Overall Summary of Joint Gulf/NRC/EID Review of Mt. Taylor

Mill Application - June 19-20, 1979

The following summarizes the advice given New Mexico EID by NRC on the Gulf Mineral Resources Co. Mt. Taylor Mill License Application tailings management plan.

REV	DATE	DESCRIPTION	APPROVED
ISSUED FOR CONSTRUCTION		CUSTOMER APPROVAL	
DESIGNED	DRAWN	REVIEWED	APPROVED
 Gulf Mineral Resources Co. GULF AFE NO. 1599			
W. A. WAHLER & ASSOCIATES PALO ALTO • NEWPORT BEACH • CALIF.			
MT. TAYLOR URANIUM MILL PROJECT LA POLVADERA CANYON TAILINGS IMPOUNDMENT GENERAL PLAN			
SCALE	PROJECT NUMBER	DRAWING NUMBER	REVISION
DATE

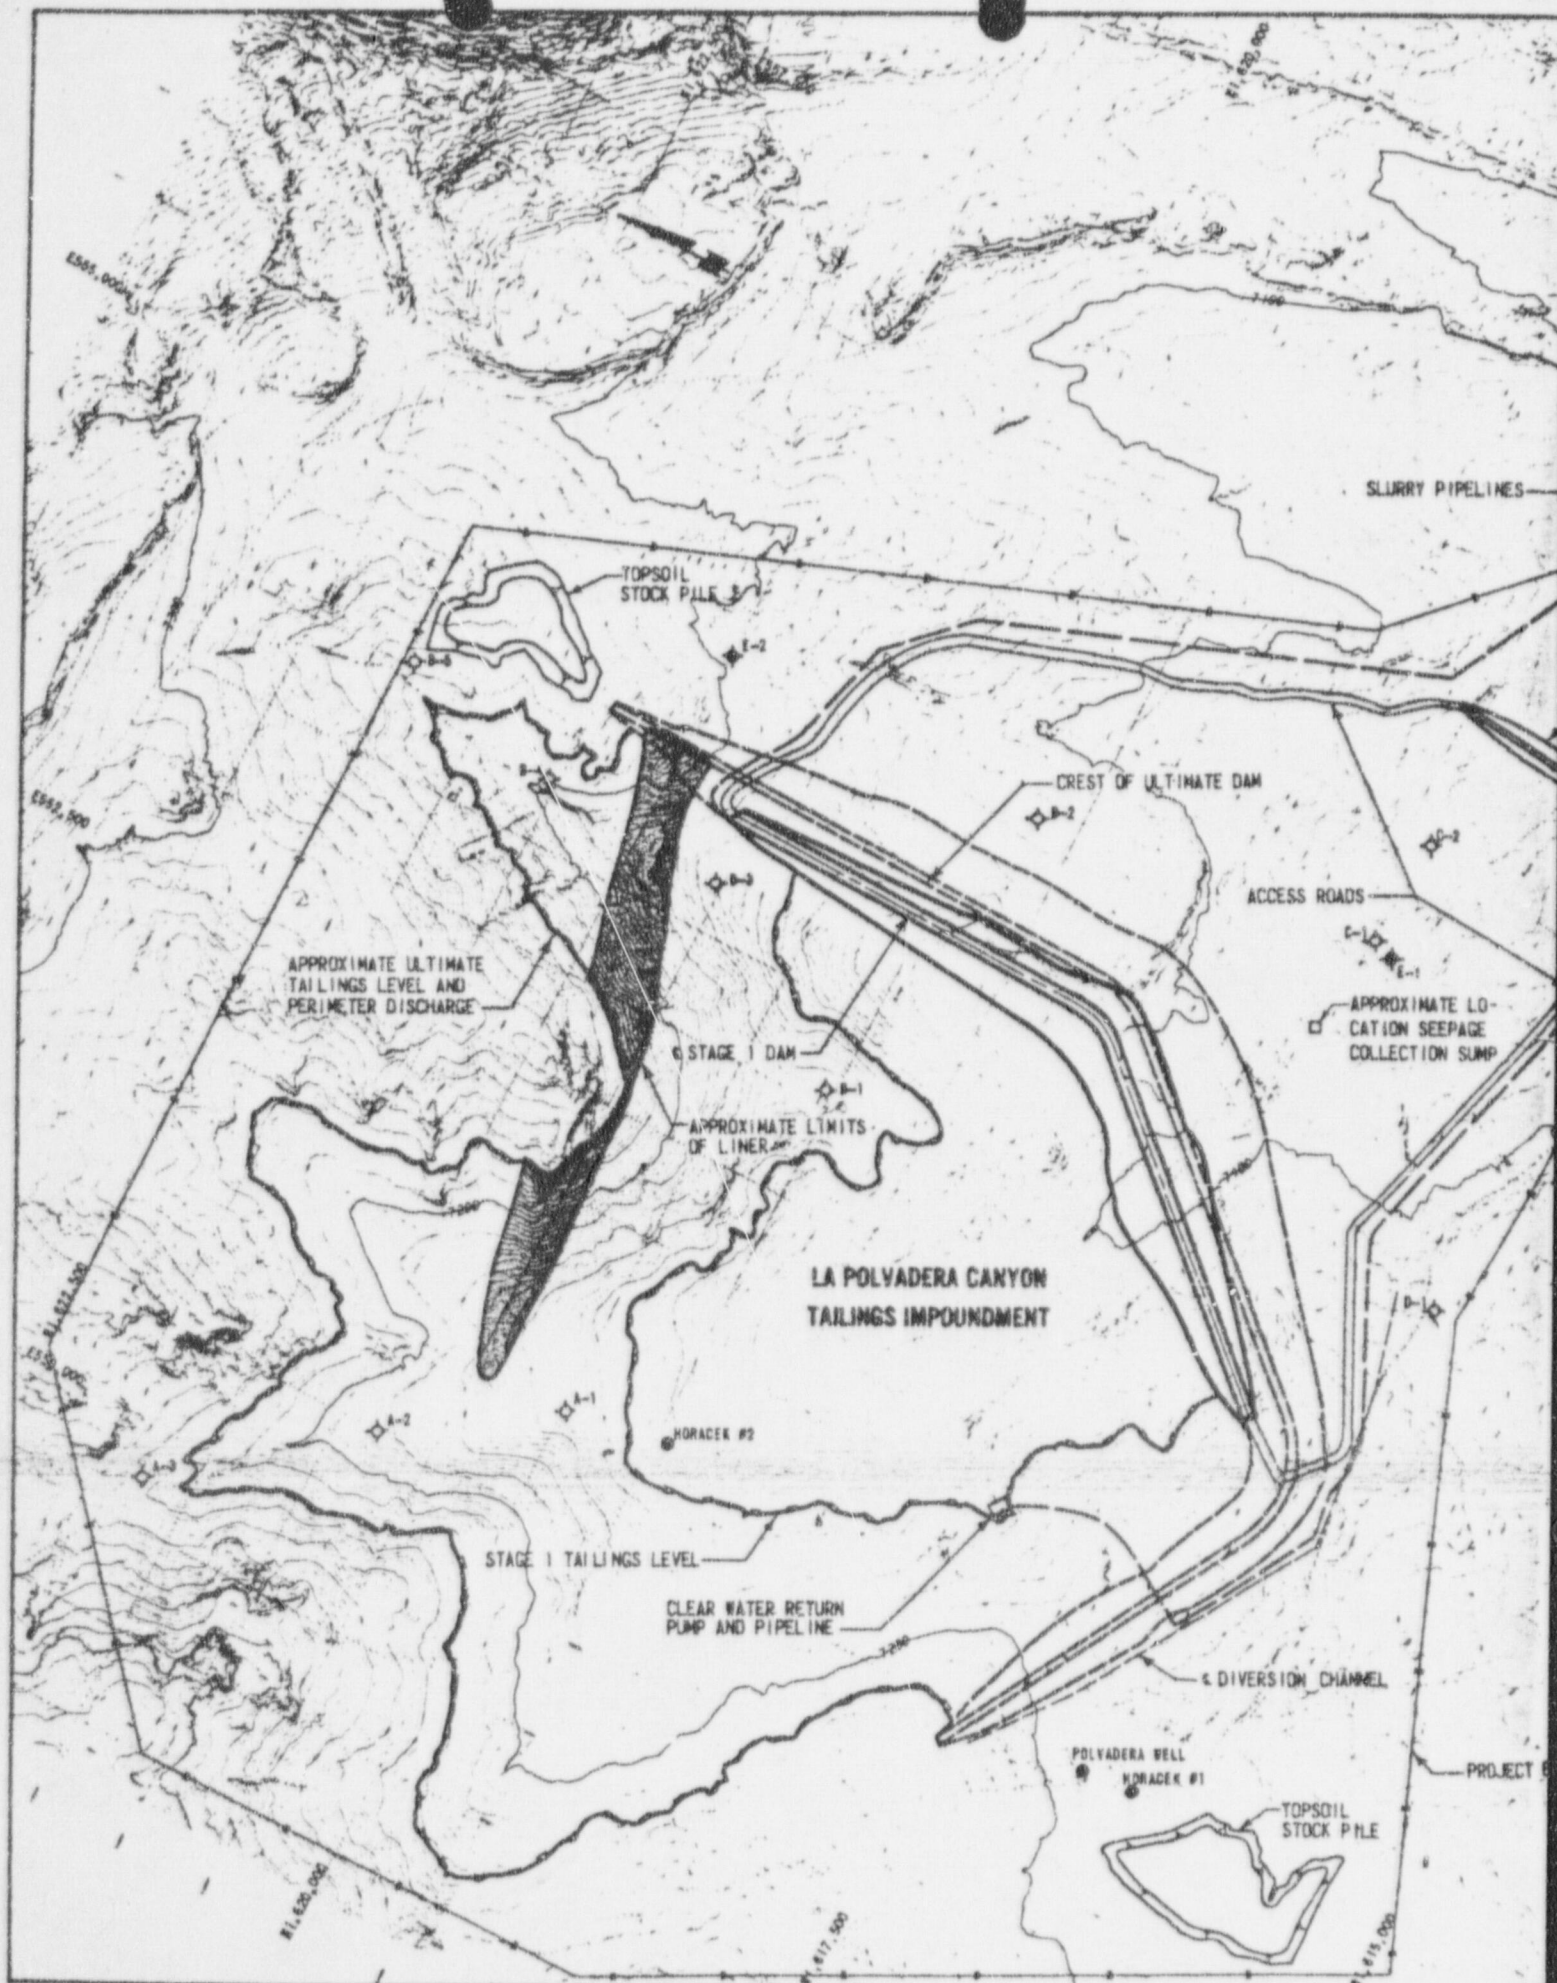
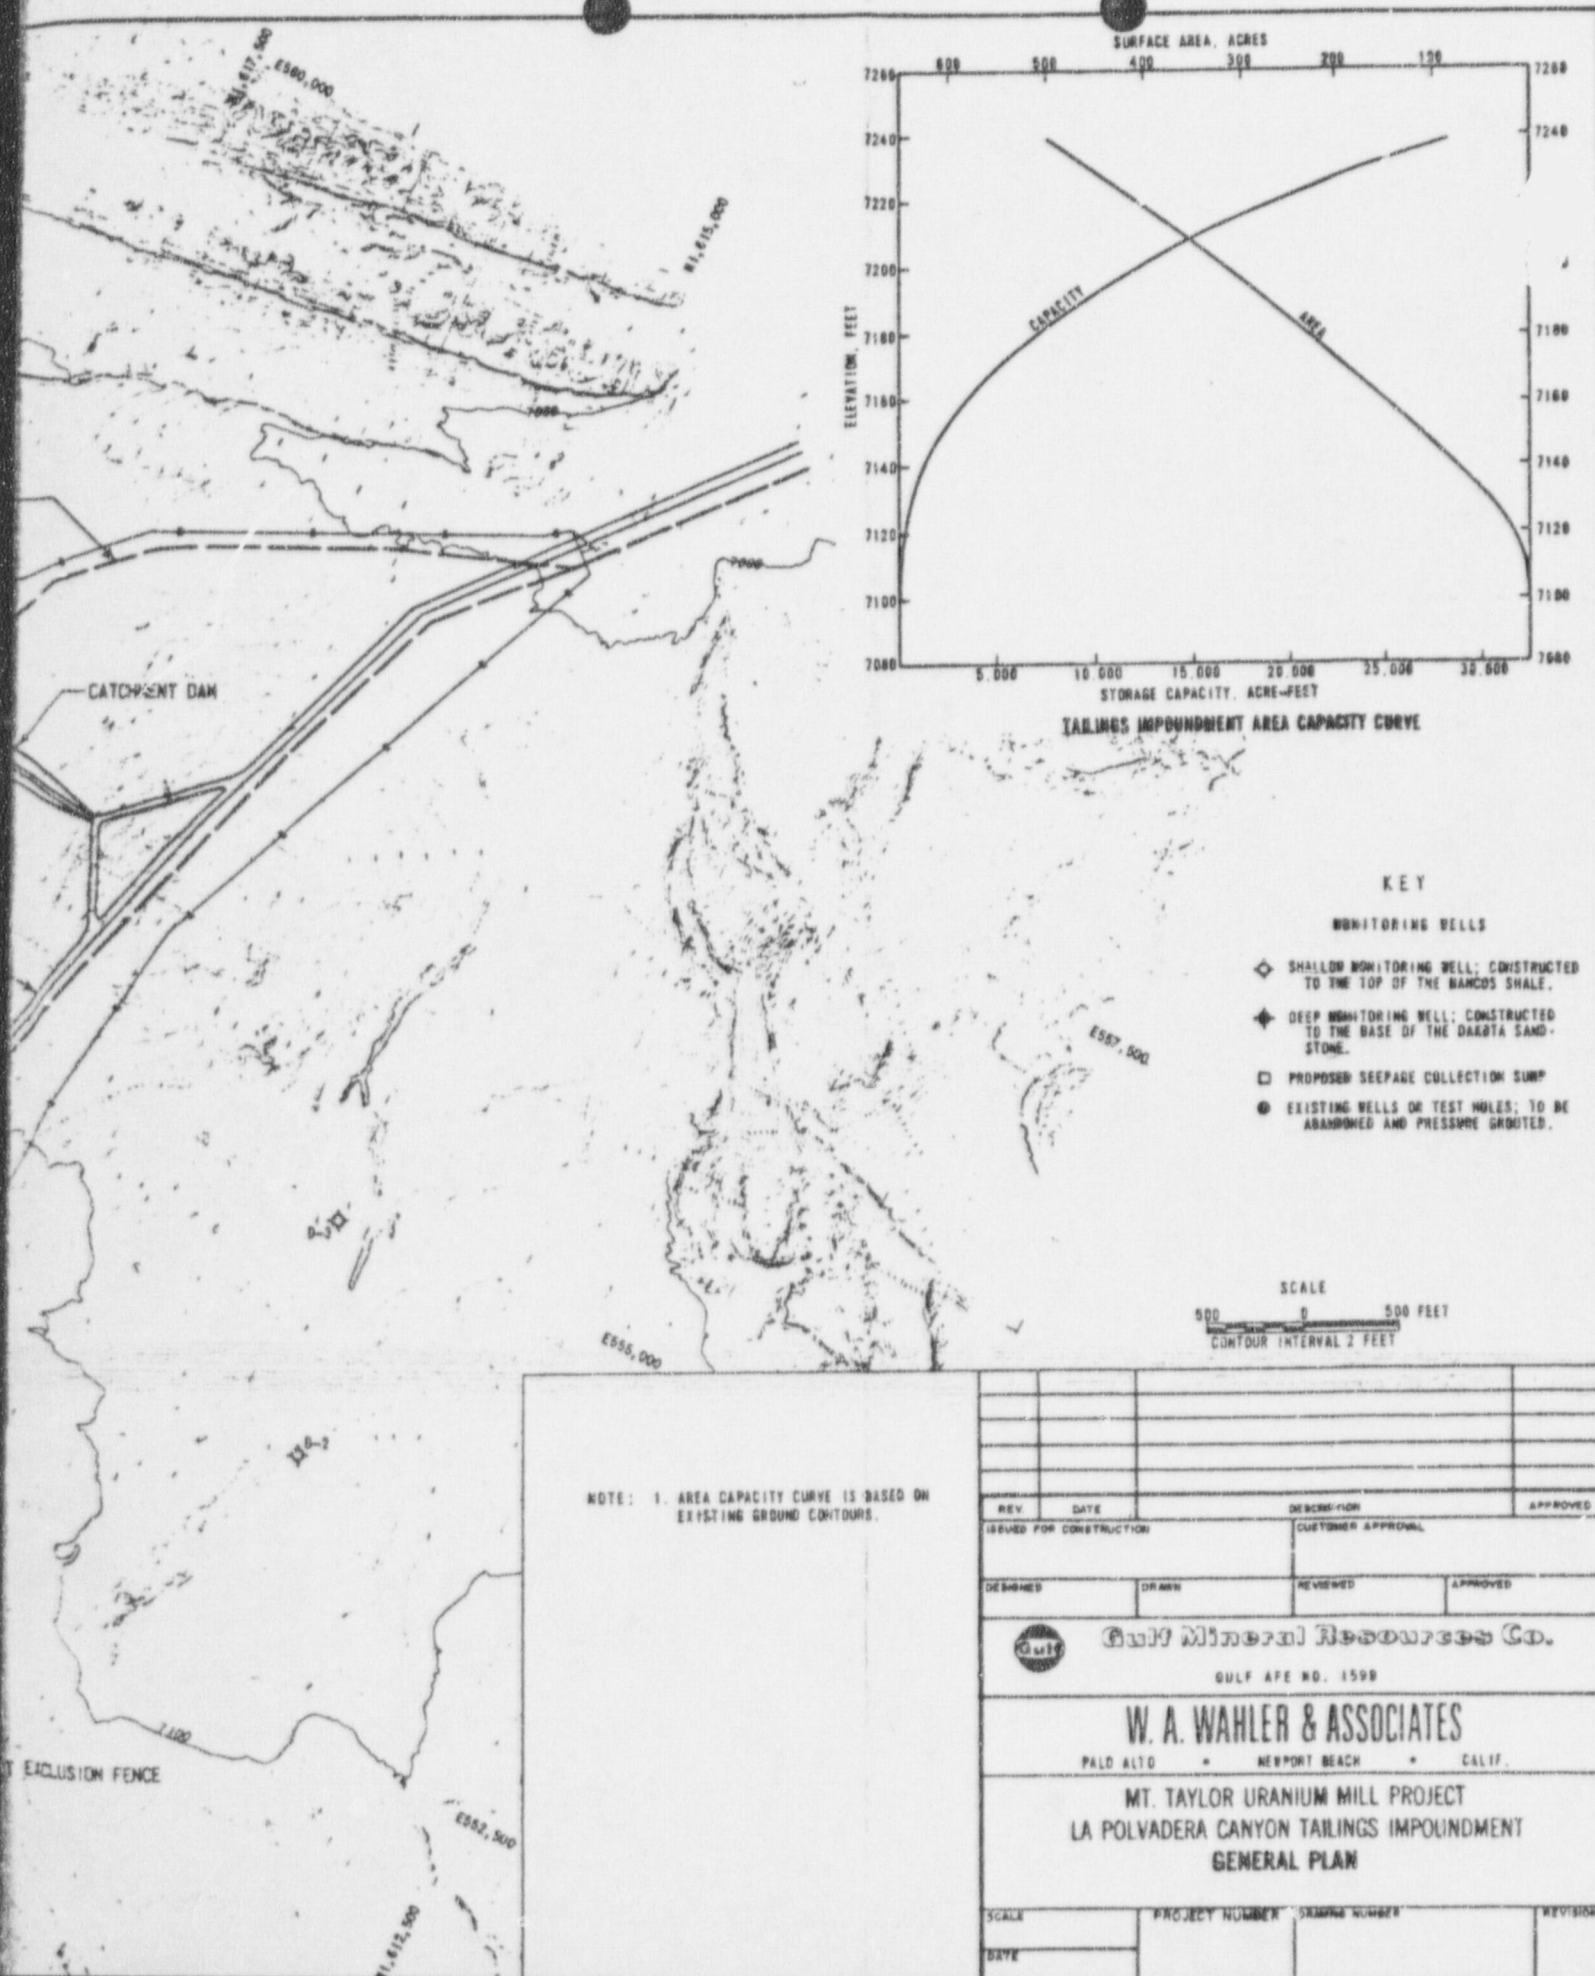
- . Evaluate volume of tailings to be disposed for the life of the project based on realistic dry density of the slimes, sands and total tails. One estimate should assume backfill of 50% of sands.

- . Evaluate how this reworked volume of tailings will effect the size of the proposed dam.
- . For La Polvadera Canyon evaluate:
 - 1) the depth to which below grade cells can be excavated (alluvium and rippable bedrock);

- 2) the cost of excavating this material;
 - 3) the staging or configuration of the cells;
 - 4) the effect of the cell configuration on seepage analyses;

- 5) whether the revised seepage analyses requires that the cells be lined, and the cost associated therewith;
 - 6) disposal of tailings in an area which extends further towards the mouth of the canyon than the presently proposed dam site. This objective is consistent with NRC's desire to dispose of tailings below grade as a prime option.

- . For San Lucas (long dam, low site) the analysis performed in the ER amendment 1 will be reevaluated given: (a) revised assumptions on tailings density; (b) disposal of 50% of sands in deep mine; and (c) more efficient cell arrangements or configurations.
